ADDENDUM 2

PROJECT: Eugene School District 4J
Chinese Immersion Program Site & Building Renovation
at Kennedy Middle School (202014)
Eugene, Oregon

DATE: February 11, 2021

RE: Changes, Revisions, Clarifications and Additions

E121

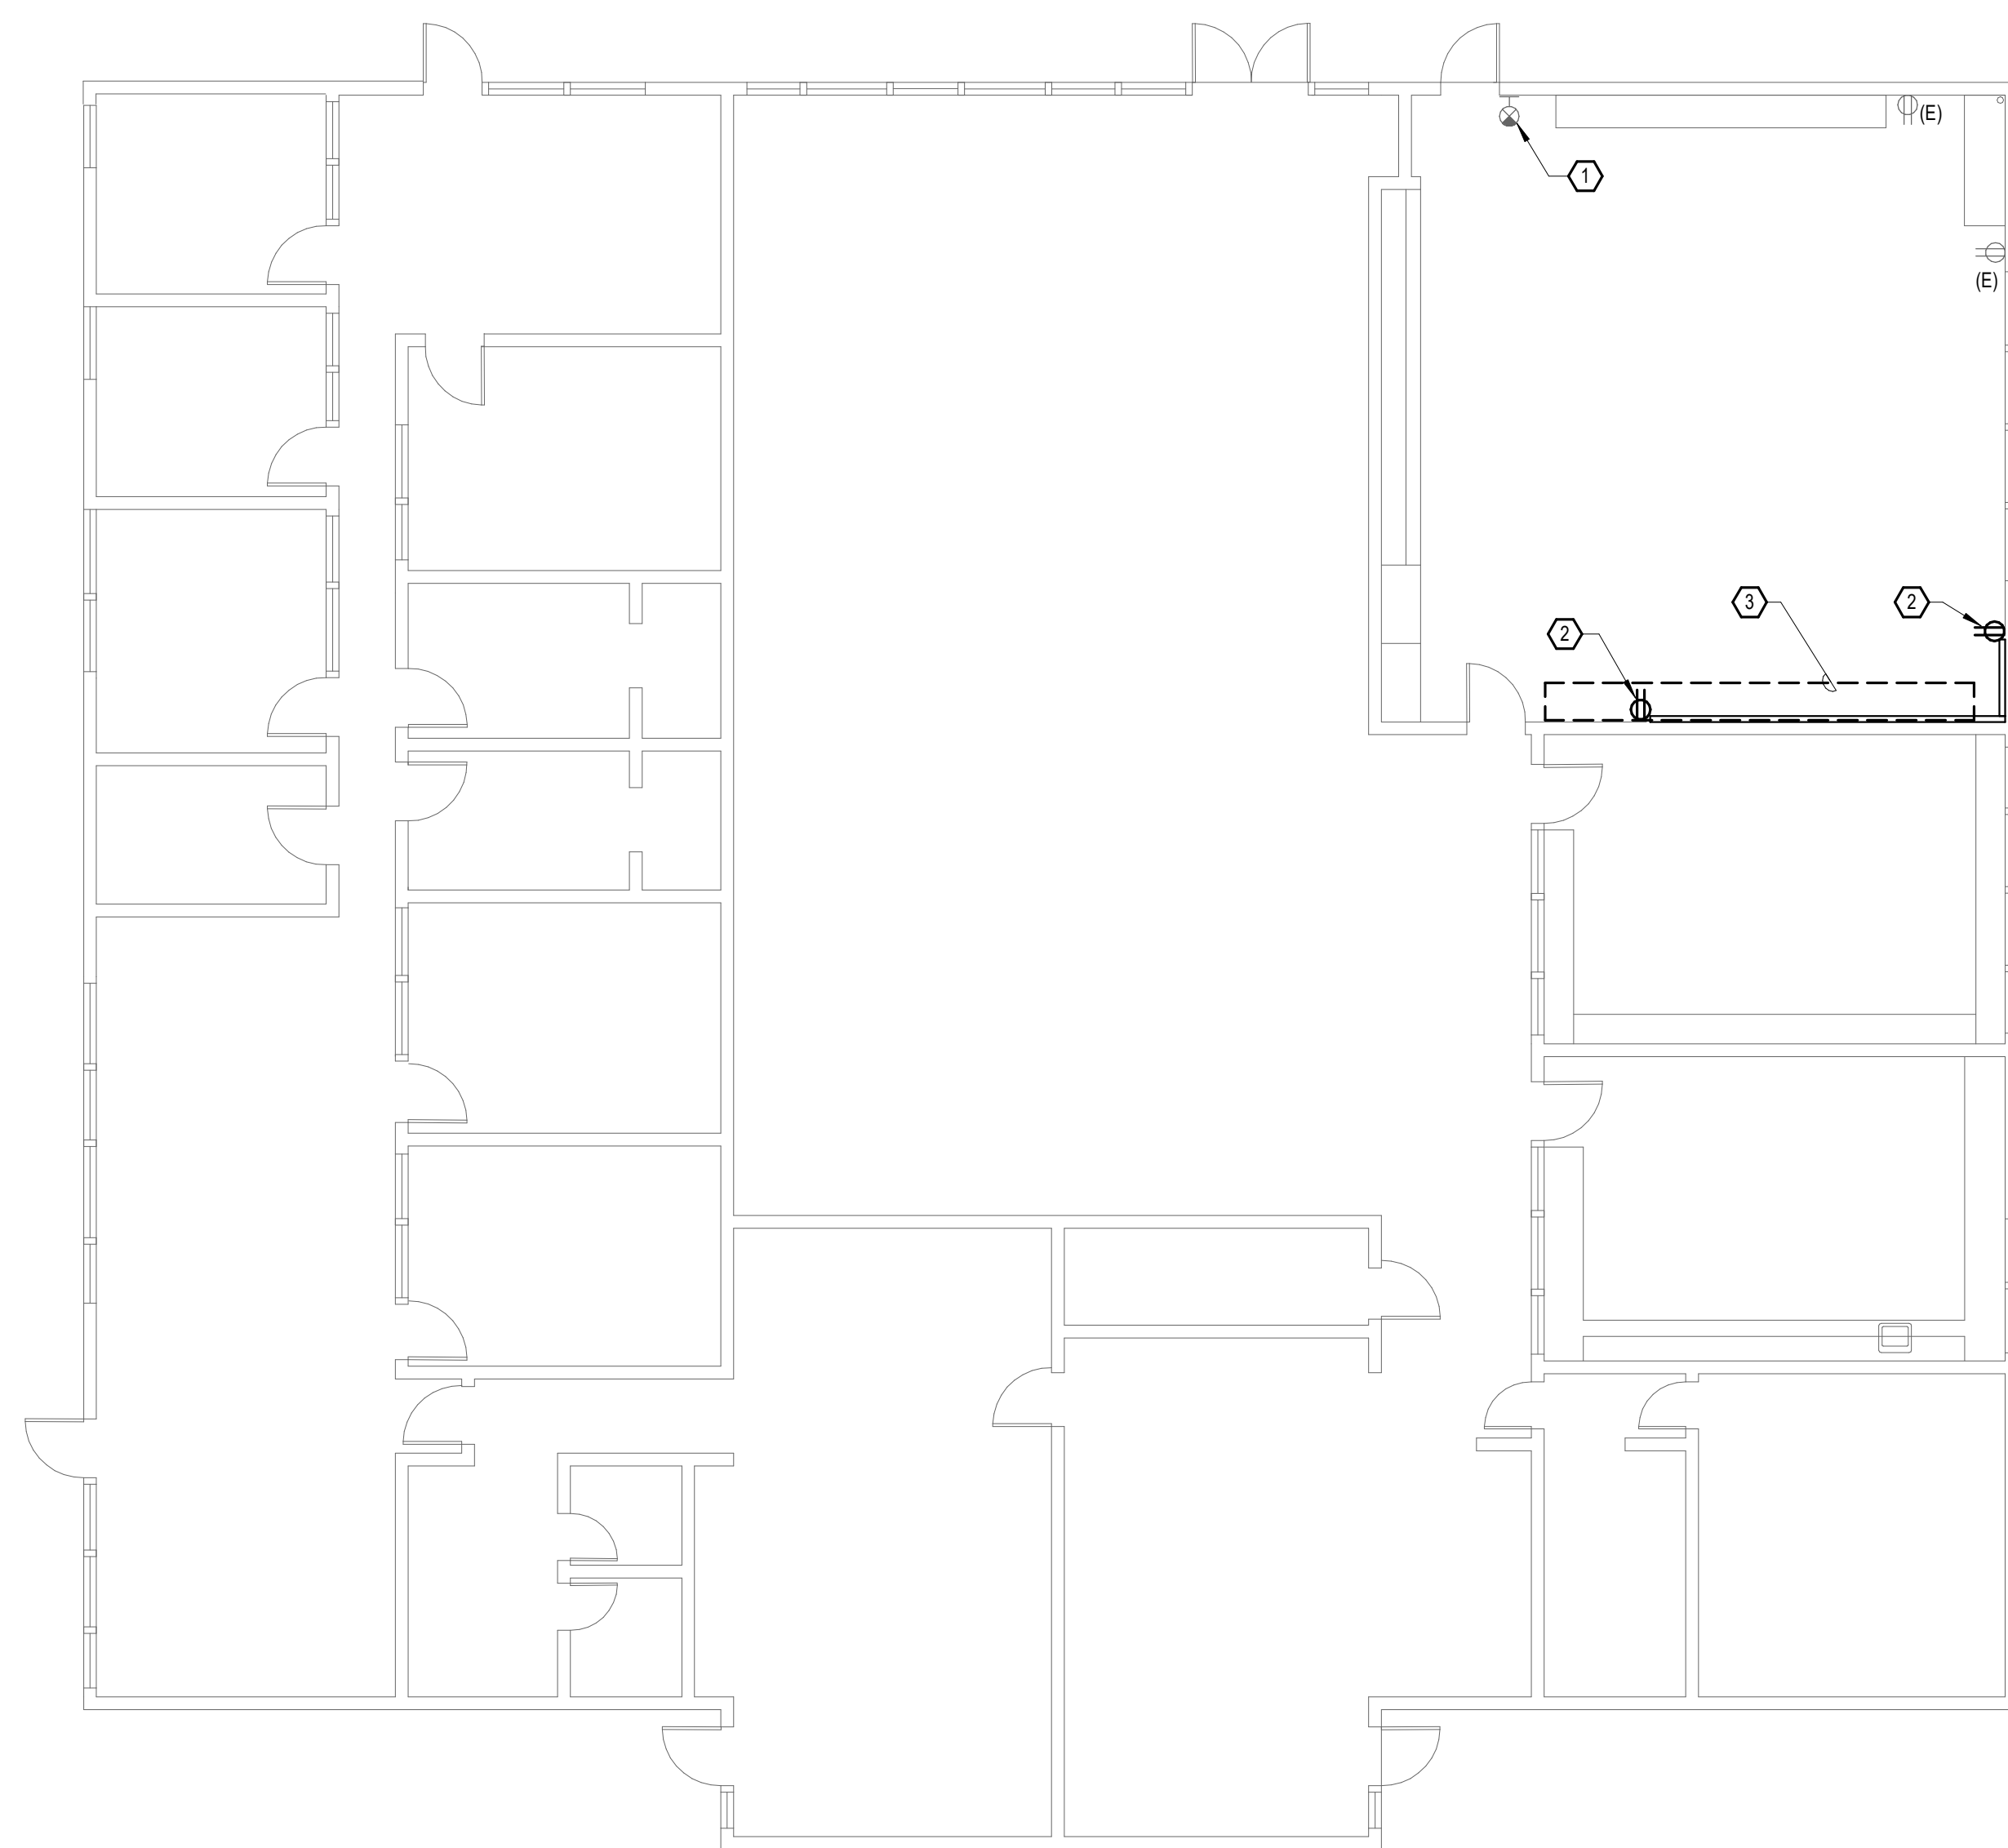
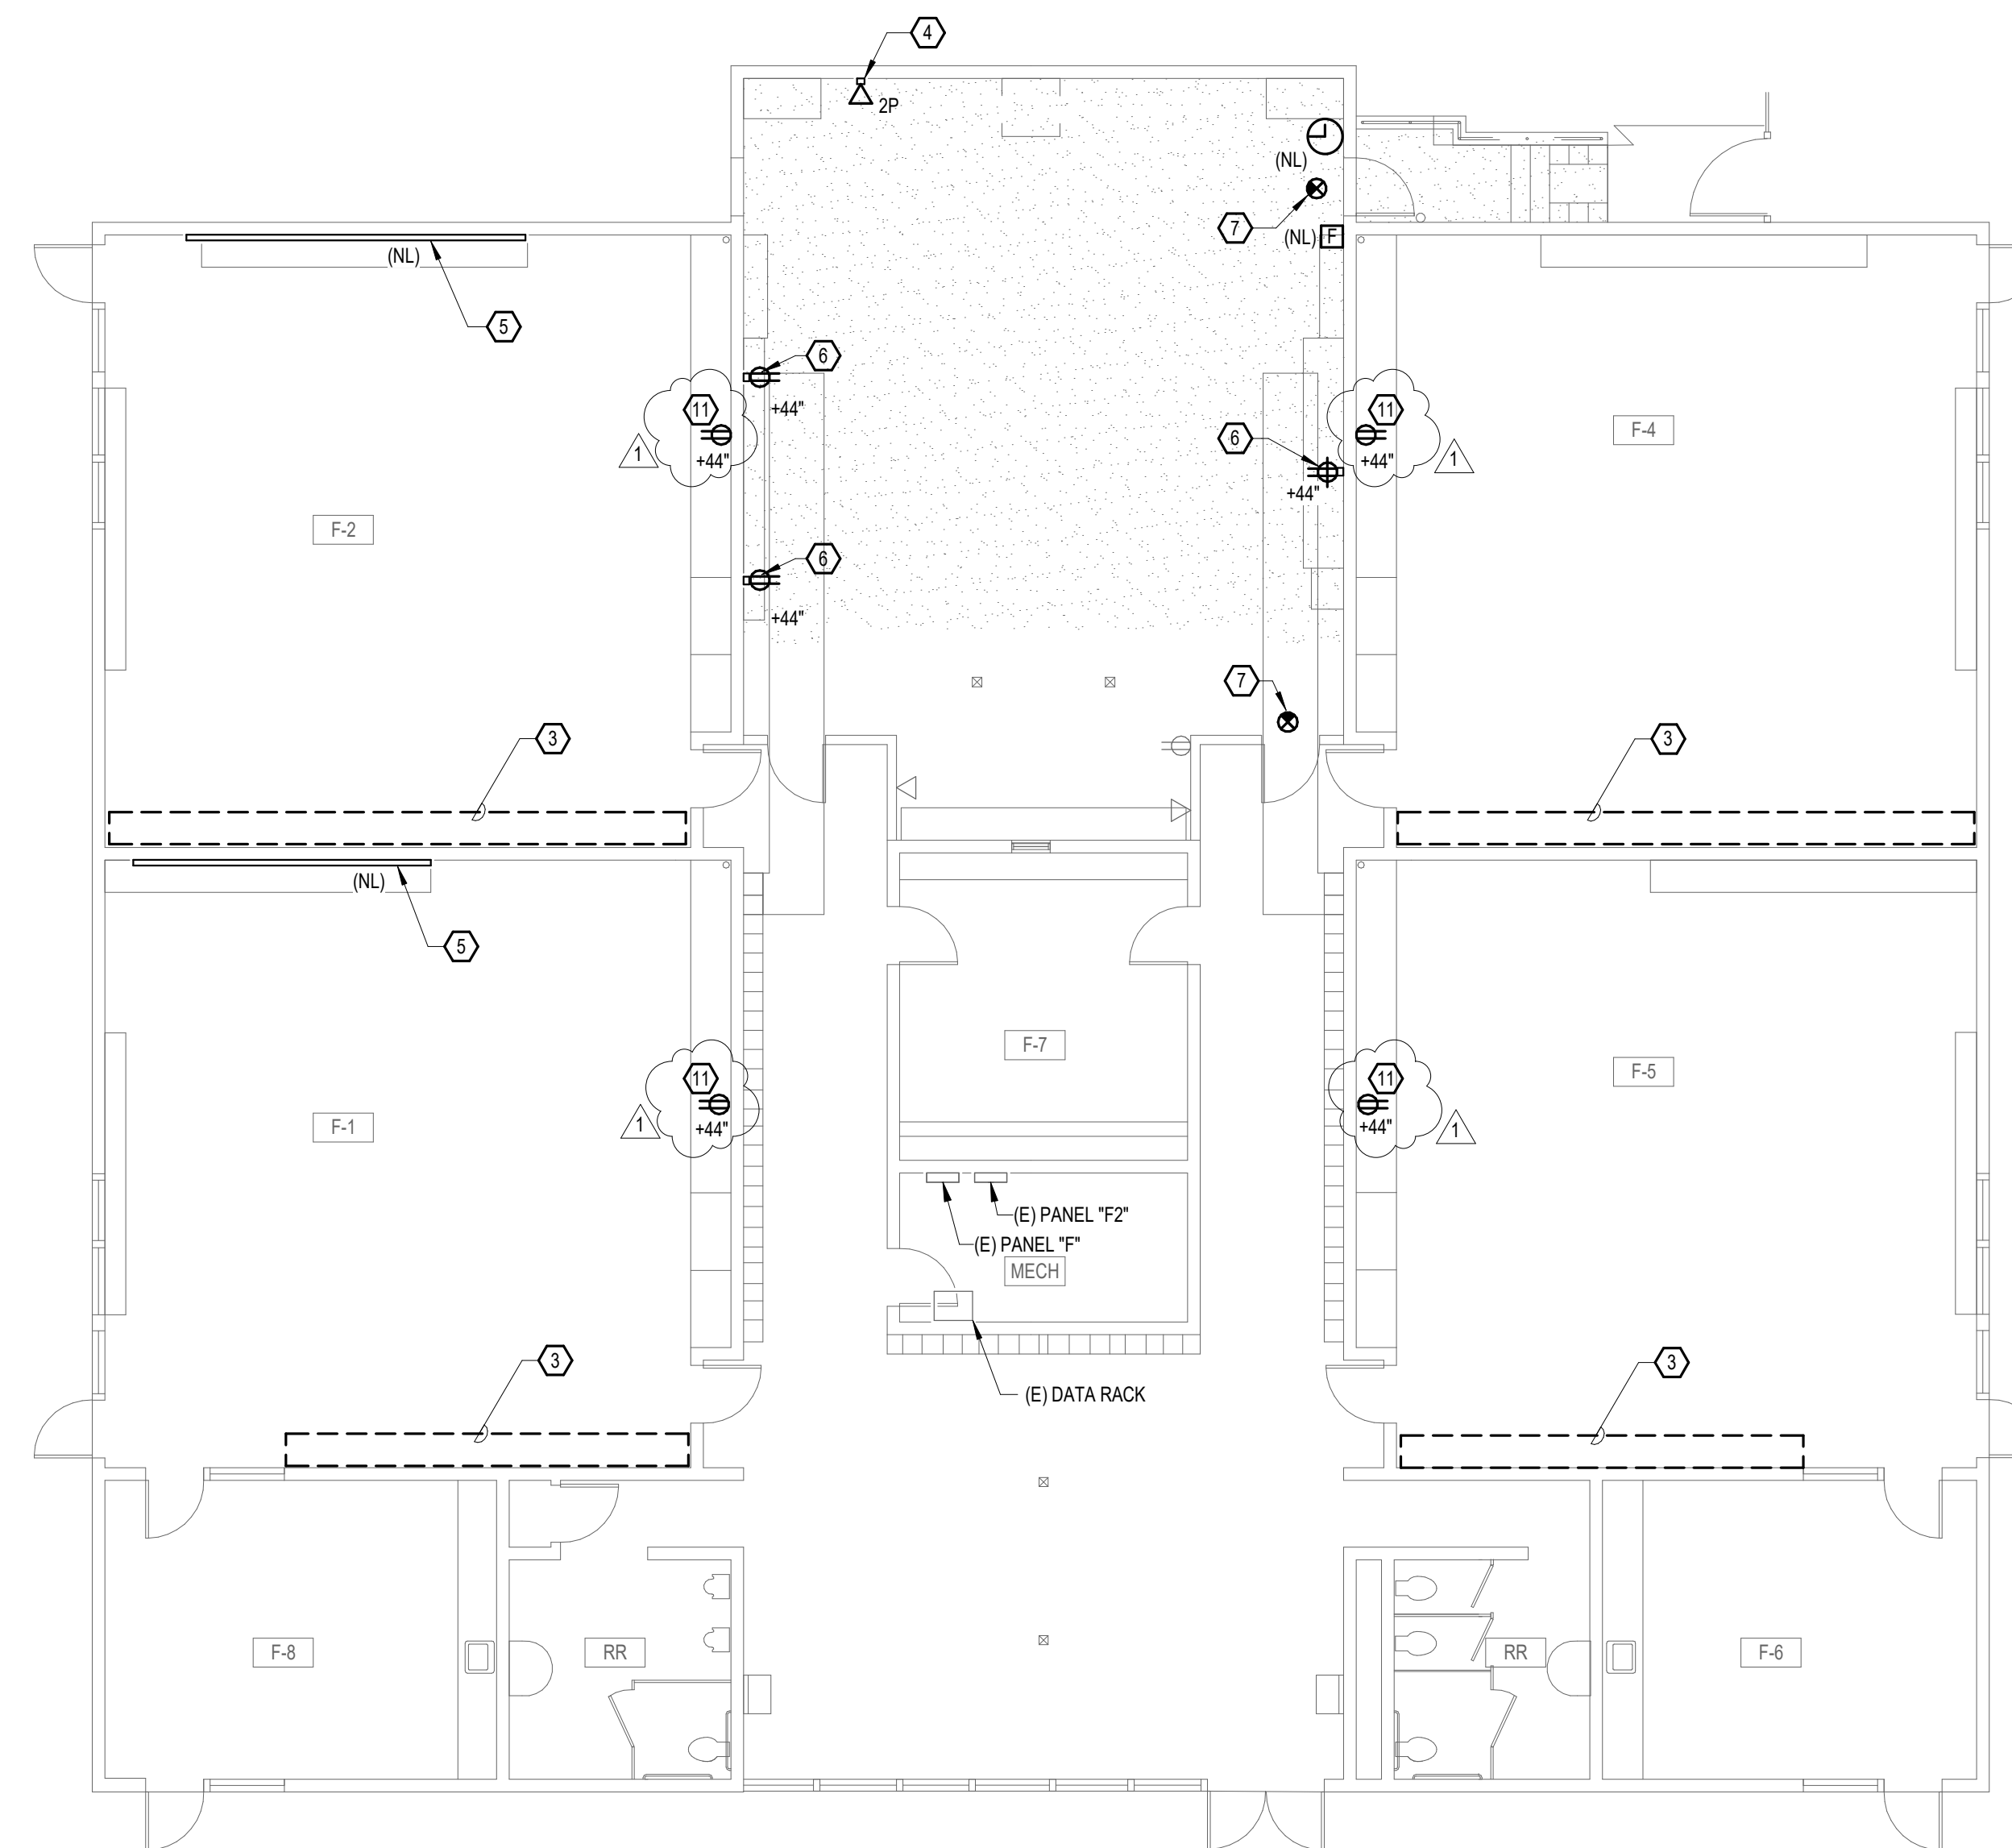
- Item 19: Reference Sheet A2.2 – BUILDING F FLOOR PLANS dated January 27, 2021, GENERAL NOTES; delete text for Items 3 and 6 and replace with the following:
- a. 3. PAINT INTERIOR WALLS OF ROOMS C-1, F-3, G-2, & G-4 IN THEIR ENTIRETY, COLOR TO MATCH EXISTING (WHITE), TYP
 - b. 6. NOT USED
- Item 20: Reference Sheet E101 – DEMOLITION PLANS dated January 27, 2021; Delete and replace with attached Sheet C101 – DEMOLITION PLANS with revisions dated February 10, 2021.
- Item 21: Reference Sheet E121 – POWER & SIGNAL PLANS dated January 27, 2021; Delete and replace with attached Sheet E121 – POWER & SIGNAL PLANS with revisions dated February 10, 2021.
